Our Ref: 16083-LE130720
Contact: Matt Cooper

**RE: SECTION 75W MODIFICATION – MP06_0143_MOD4
THE GLADES ESTATE, MOONEE BEACH**

Appendix A – Response to DPE Matters

Project **THE GLADES ESTATE - BULK EARTHWORKS**
 Title **SECTIONS PLAN**
LOT 1 DP 725785
PACIFIC HIGHWAY - MOONEE BEACH

LONGITUDINAL SECTION - SECTION G

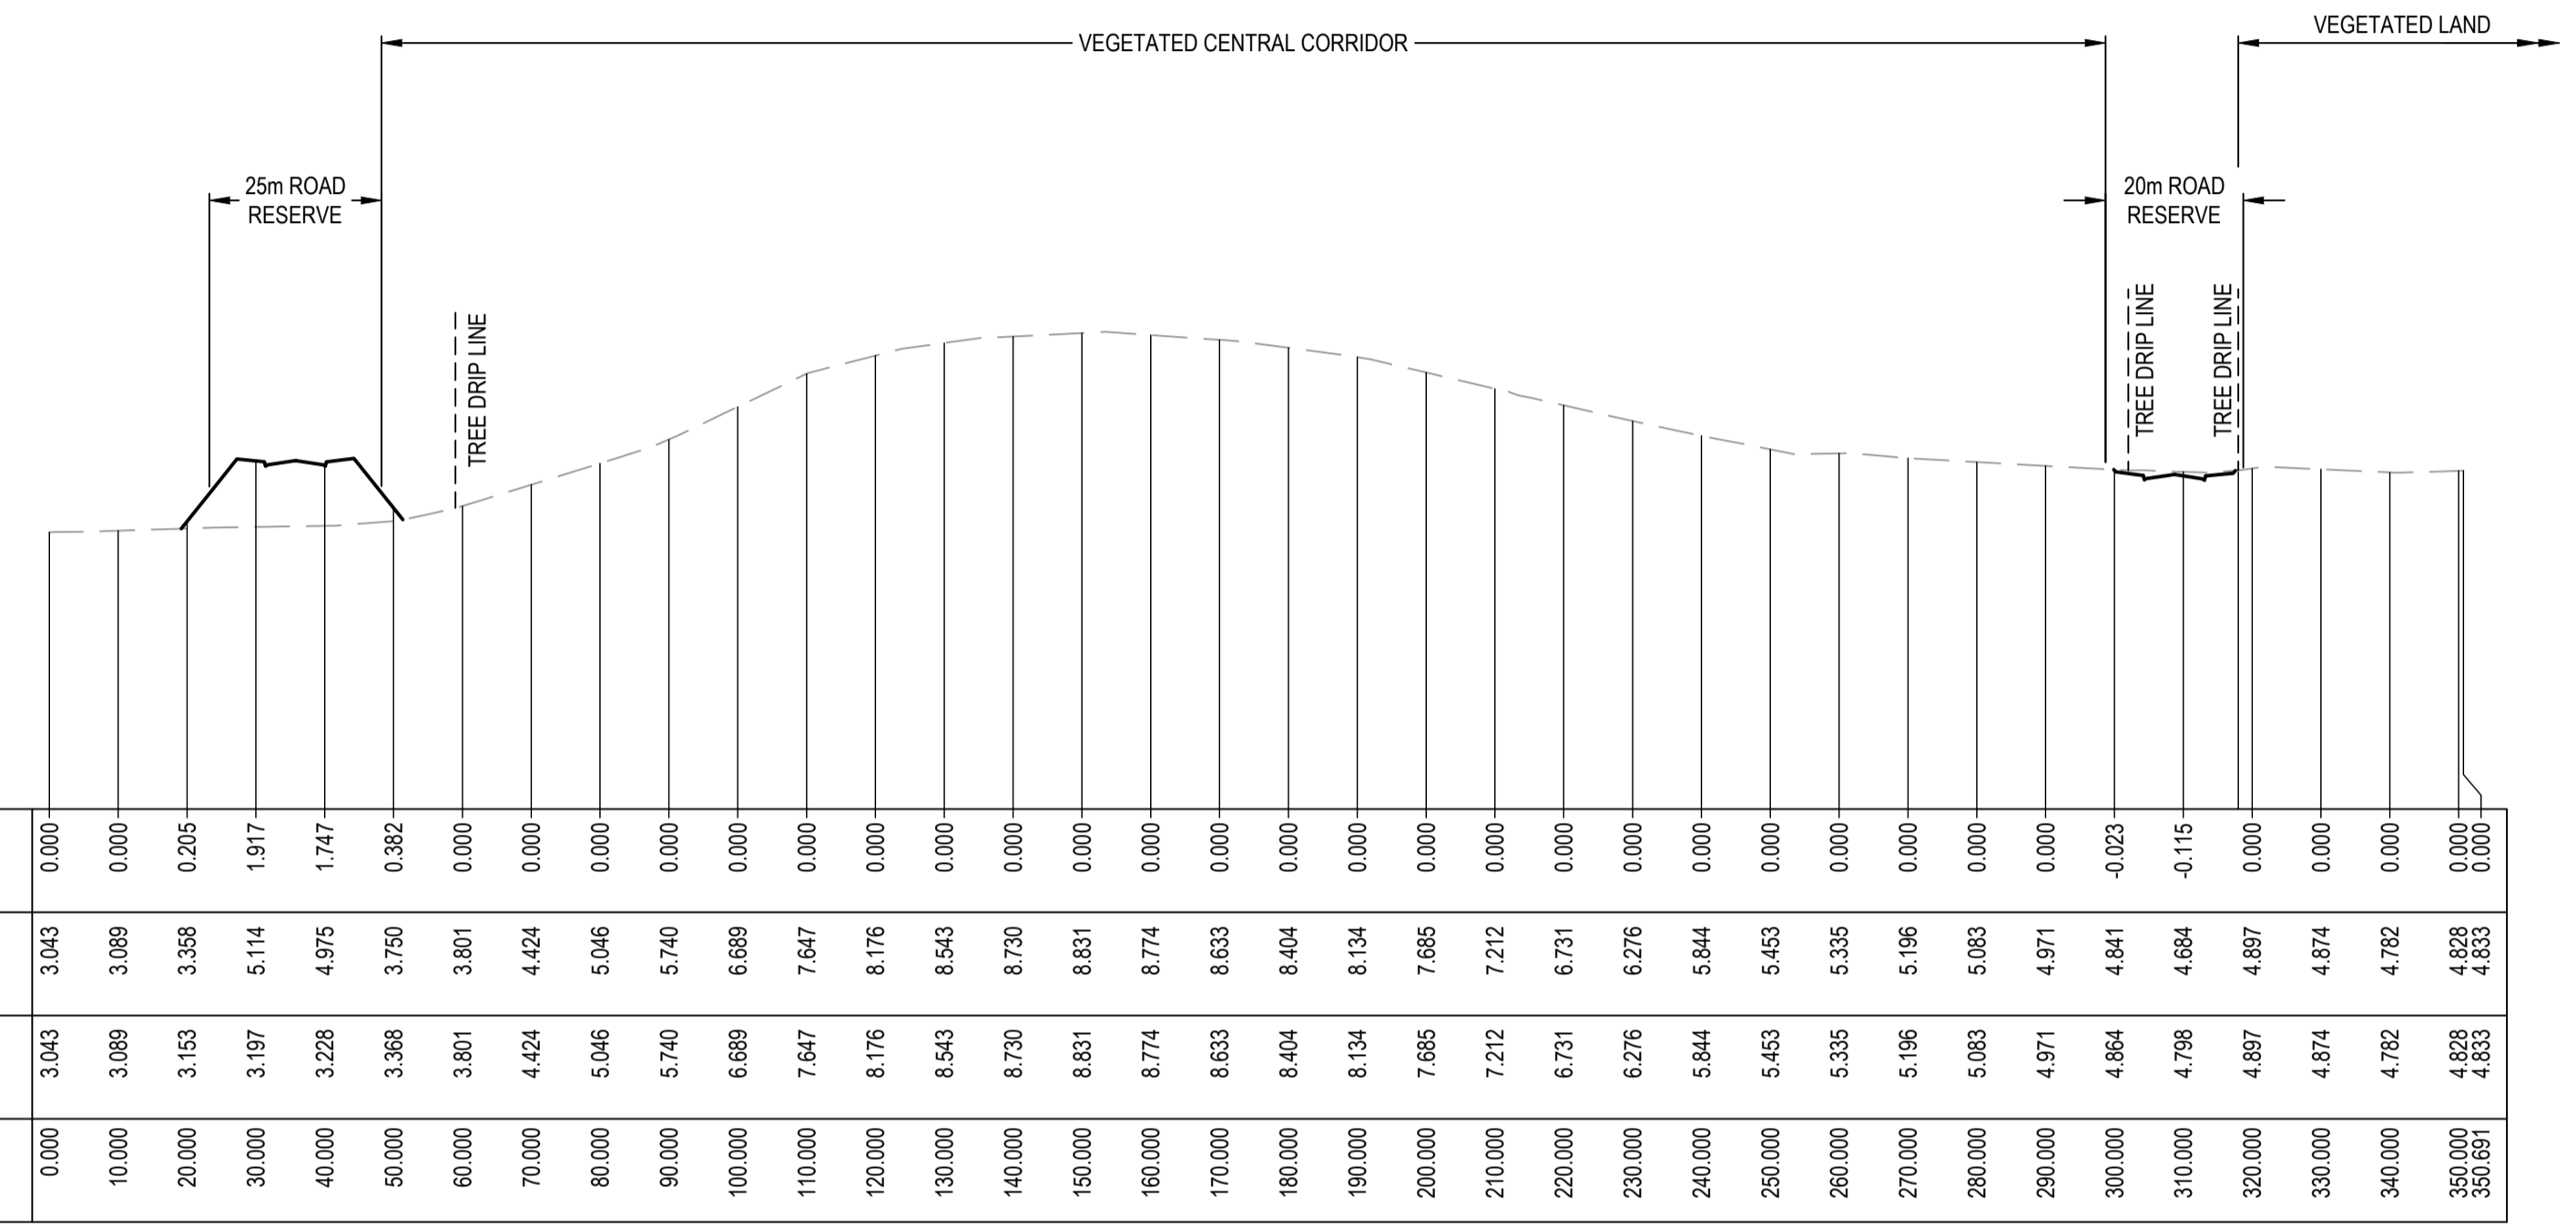
Correspondent	Issues Raised	RDM's Response
		<p>infrastructure have not changed since Council's assessment referred to in their letter dated the 20th of June 2016.</p> <p><i>Note: Council's letter 20th of June 2016, should in fact be 20th of June 2019.</i></p>
	<p><u>Earthworks in vicinity of the vegetation corridor:</u></p> <ul style="list-style-type: none"> ▪ <i>Based on the information provided, it is our understanding that levels around the corridor appear to align with the existing topography on the site, except along the southern corridor boundary.</i> ▪ <i>On this basis, it is requested that further clarity is provided in relation to the corridor and how it will be integrated into the surrounding landscape.</i> 	<ul style="list-style-type: none"> ▪ The attached drawings show longitudinal sections through the site, demonstrating that the roads surrounding the central vegetated corridor generally match the existing ground levels within the vegetated corridor, that is, apart from the southern edge of the vegetated corridor. <p>The proposed road level along the southern edge of the vegetated corridor is however consistent with the fill level of 4.75m required by Condition D6(1) MP06_0143 dated the 5th of March 2009.</p> <p>Notably, longitudinal Section G, (Plan Reference 16083-E-CC204) shows the revised road levels at this location to be 5m (approx.) which is approximately 0.25m higher than what is required by current Condition D6(1). This minor height difference is necessary to satisfy Council's road and drainage design standards.</p> <ul style="list-style-type: none"> ▪ Please refer to RDM's Bulk Earthworks Plans 16083E-CC200 to 16083E-CC204. <p>Please note that CC201 & CC204 include Longitudinal Sections A & G which show the position of the internal road reserve surrounding</p>

Correspondent	Issues Raised	RDM’s Response
	<ul style="list-style-type: none"> ▪ <i>An indicative plan demonstrating cross sections would assist to outline how the land will undulate and integrate into the proposed surrounding levels and proposed mitigation or management of any identified impacts, such as stormwater runoff (if applicable).</i> ▪ <i>Similarly, an indication of the potential impacts on the structural root zones of existing vegetation identified for retention within the corridor would be appreciated and if there is any required mitigation (if applicable).</i> 	<p>the vegetated corridor along with the existing and proposed bulk earthworks levels at their interface.</p> <p>As demonstrated on each Longitudinal Section, the bulk earthworks levels at the road reserve/vegetated corridor interface for the western, northern and eastern alignments coincide with the natural ground level at that location. The bulk earthworks level for the southern alignment remains consistent with the bulk earthworks level approved under MP06-0143.</p> <ul style="list-style-type: none"> ▪ With regard to the stormwater runoff at the northern and southern ends of the vegetated corridor, this will be conveyed under the proposed road through suitably designed culverts. This arrangement is consistent with the approved stormwater strategy and in accordance with Council’s requirements ▪ RDM’s Bulk Earthworks Plans (attached as 16083E-CC200 to 16083E-CC204) shows the interface between the central vegetation corridor and the road reserve boundary. Please refer to Longitudinal Section A & G. <p>With regard to 16083 E-CC200, the drip line of the existing vegetation is also shown relative to the approved road reserve.</p> <p>With reference to the above:-</p> <ul style="list-style-type: none"> a) Any impact to existing vegetation (structural root zones) at the southern interface will be
